Report to the Future Melbourne (Planning) Committee

Agenda item 6.5

Planning Permit Application: TP-2016-225, 69 Hardiman Street, Kensington 7 February 2017

DELEGATED PLANNING APPLICATION REPORT

SITE/GROUND FLOOR PLAN
 SCALE 1 : 100

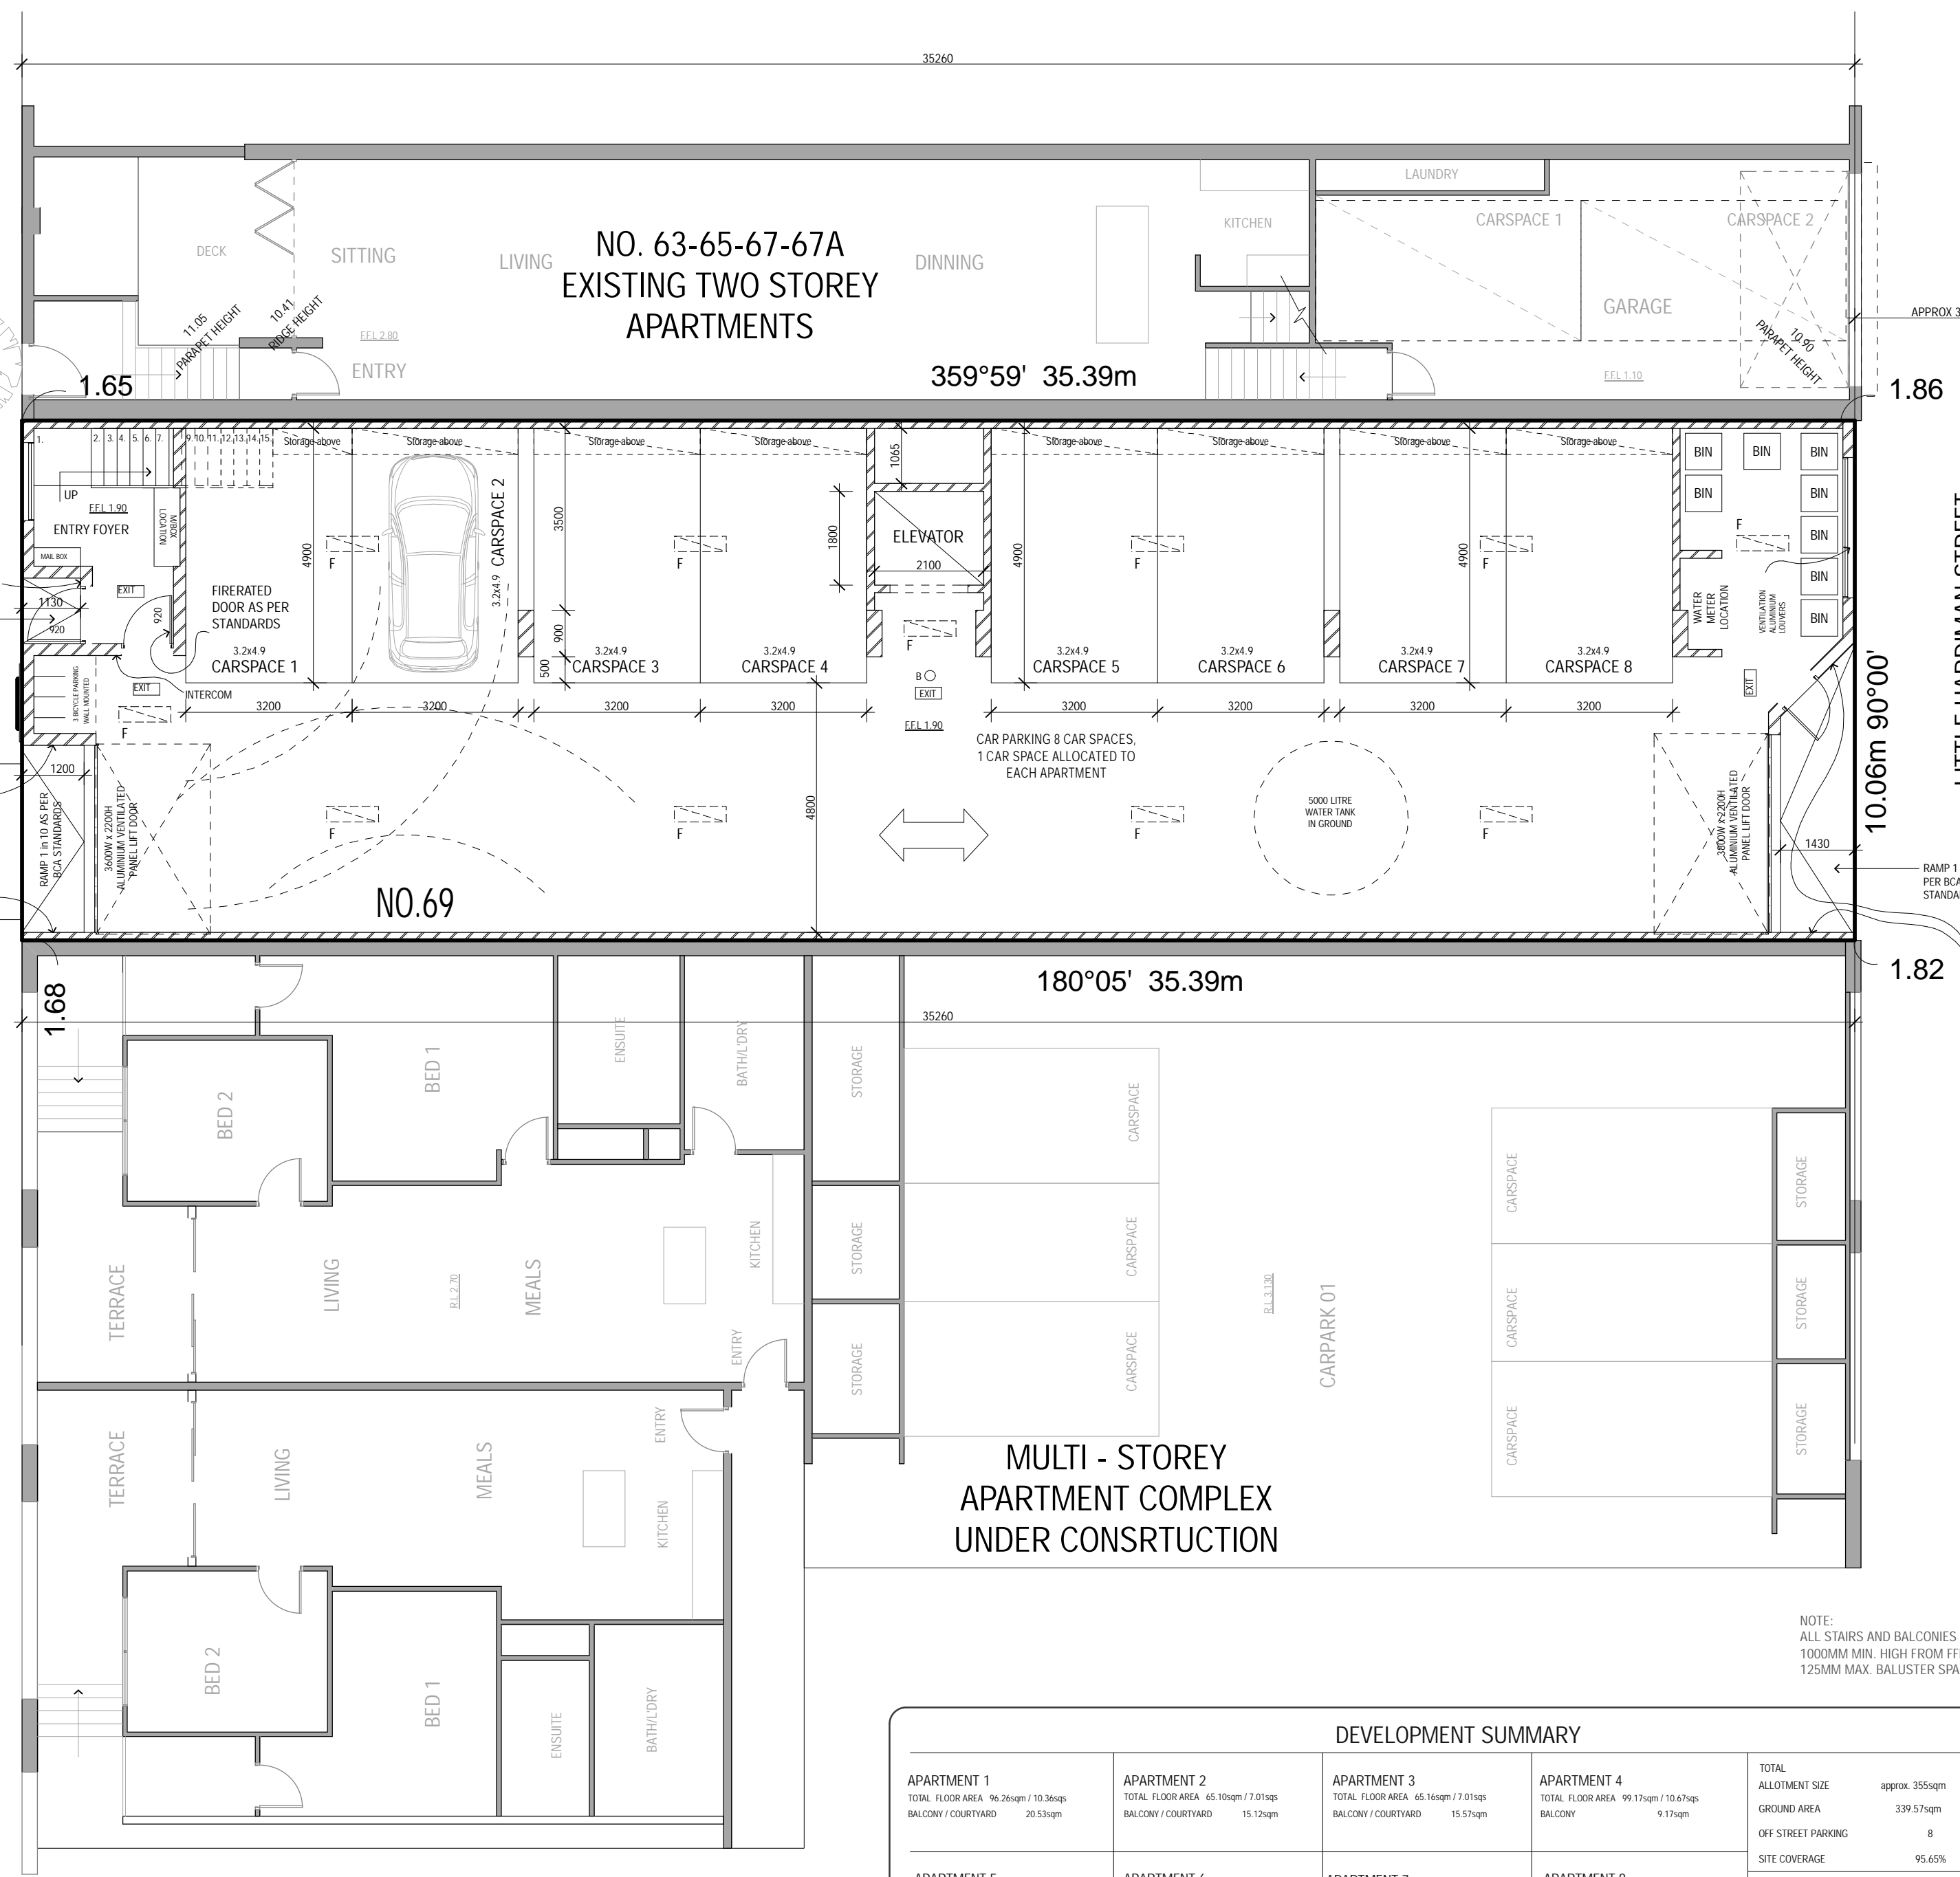
From the information and plans provided, it appears that the development proposal is very similar to the previous proposal. The carpark layout plan shows that each parking spaces is proposed to be 3.2 metres wide and 4.9 metres long accessed from a 4.8 metre wide isle.

These dimensions are in accordance with Planning Scheme requirements and therefore Engineering Services offers no objection to the carpark layout, including the provision of bicycle parking facilities. It would be preferable to provide one bicycle parking space for each dwelling, however it is accepted that the proposed number complies with Planning Scheme requirements.

The parking allocation for each dwelling also complies with the Planning Scheme requirements and therefore no objection is offered in this regard. Engineering Service accepts the waiver of the visitor parking requirement of one space. It should be noted however that as this development proposal increases the residential density, residents of this development will not be eligible for resident parking permits.

Figure 3: Notated excerpt from 'East Elevation Plan' prepared by NRG Building Designs Pty Ltd

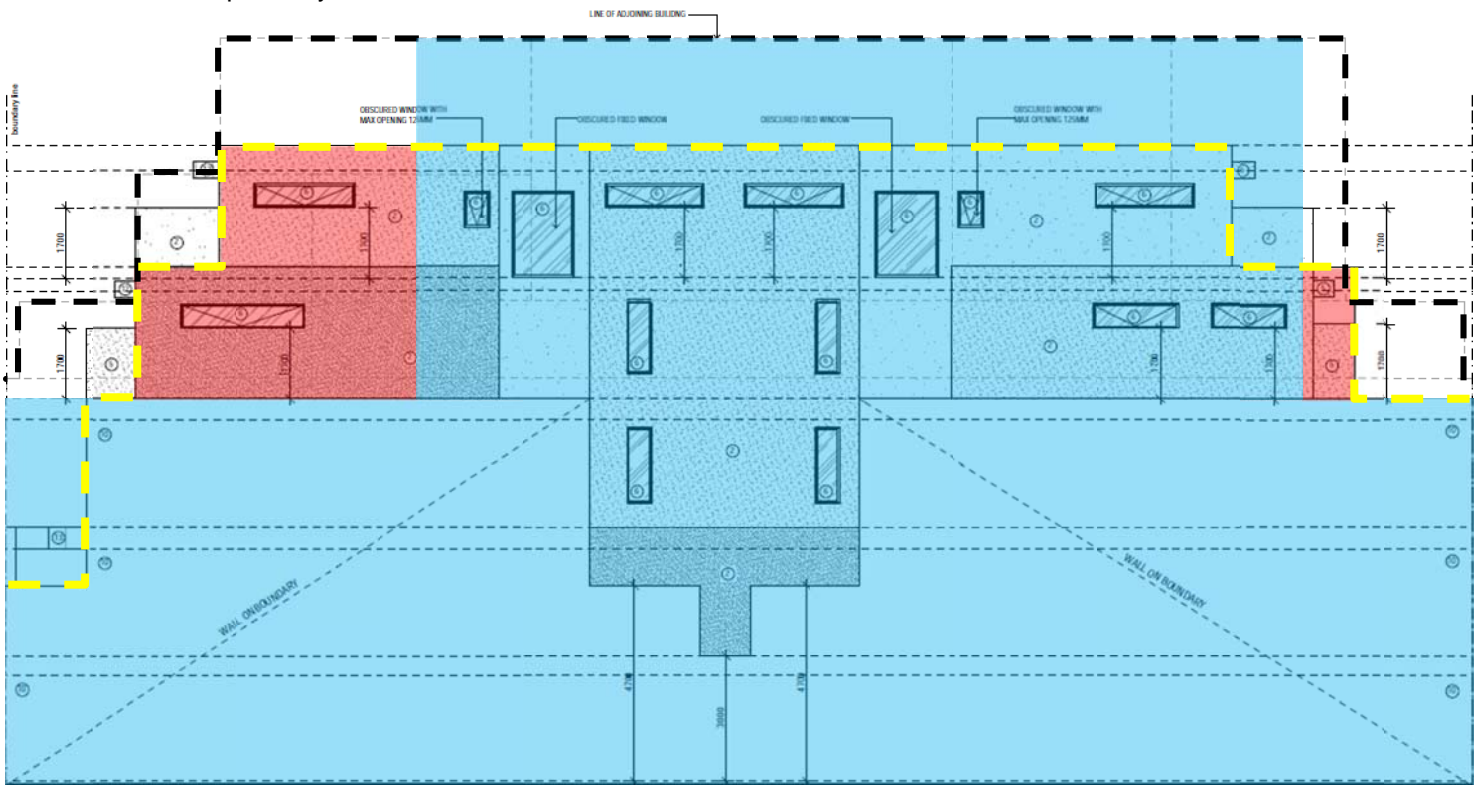
Figure 3 provided overleaf identifies the building envelope for the site contemplated by DDOC190 (blue) and encroachments beyond this building envelope (red).

The silhouette of the adjoining residential apartment building at 18 Bent Street and the proposed development are also delineated in bold black and yellow dashed lines, respectively.

The proposed development, including the variations from the preferred development setbacks above the street-wall height, are considered acceptable having regard to the relevant design objectives and built form outcomes specified in DDOC190 for the following reasons:

- The development complies with the preferred street wall height of 3 storeys under DDOC190, adopting a reduced street wall height of 2 storeys to Hardiman Street, and a street wall height of 3 storeys to Little Hardiman Street.
- The development, whilst not achieving the preferred 10 metre setback above a street wall height of 3 storeys to Hardiman Street, is considered to provide an appropriately recessive building envelope for the following reasons:
 - The setbacks above the street wall height are respectful of the upper level setbacks of the adjoining property at 18 Bent Street;
 - Meaningful setbacks to the east and west property boundaries will ensure that the development is visually recessive at oblique angles; and
 - An articulated façade with varied materials above the street wall will distinguish upper levels from a clearly defined street edge.

Figure 4: Notated excerpt from the 'Third Floor Plan' prepared by NRG Building Designs Pty Ltd

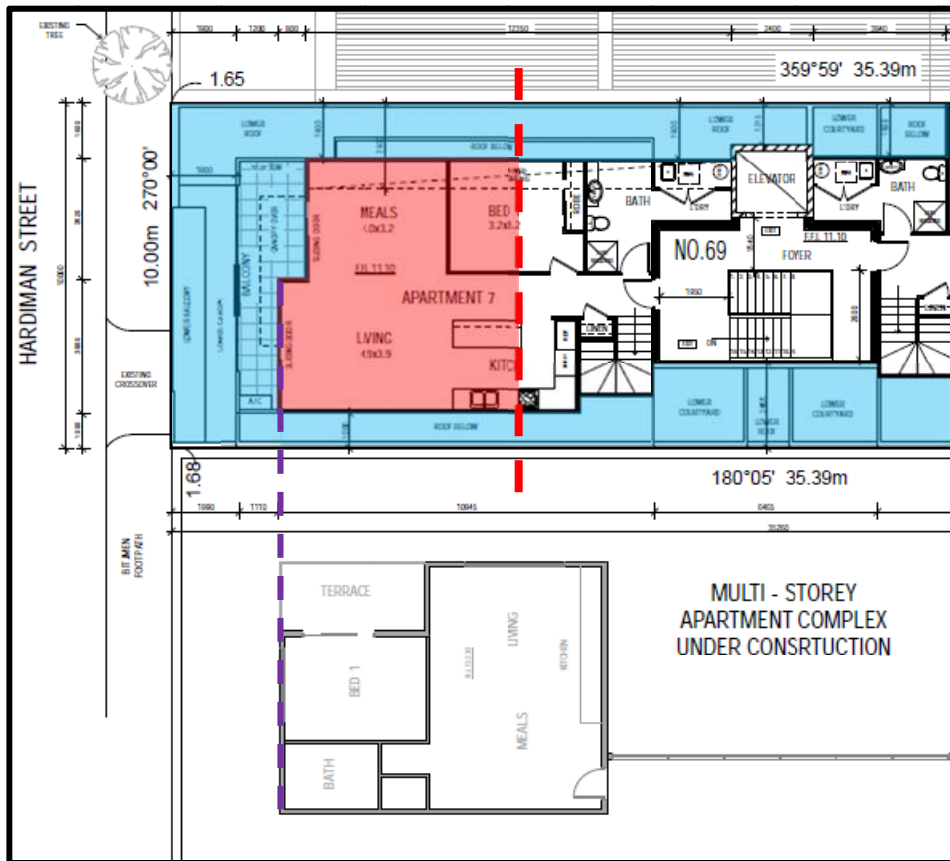
Figures 4 and 5 below and overleaf depict the visually recessive third and fourth floors to the building, highlighting the extent of floor area encroaching beyond the preferred 10 metre setback (red), setbacks (blue), and the shared front setback with the adjoining residential apartment building at 18 Bent Street, Kensington (purple line).

Figure 5: Notated excerpt from 'Fourth Floor Plan', prepared by NRG Building Designs Pty Ltd

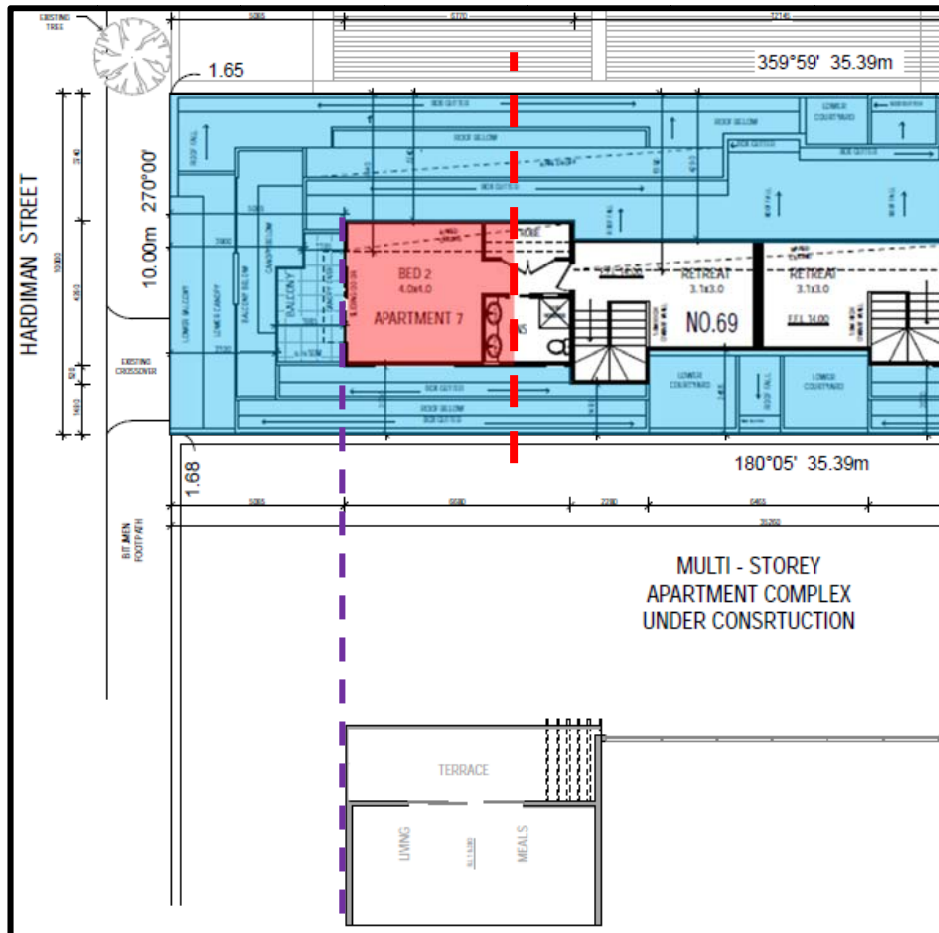
- Broadly, it is considered that the development will provide suitable street definition; will ensure appropriate access to sunlight and daylight for Hardiman Street, and represents an appropriate response to the amenity of existing residential development (as per the assessment undertaken in section 11.4 of this report).
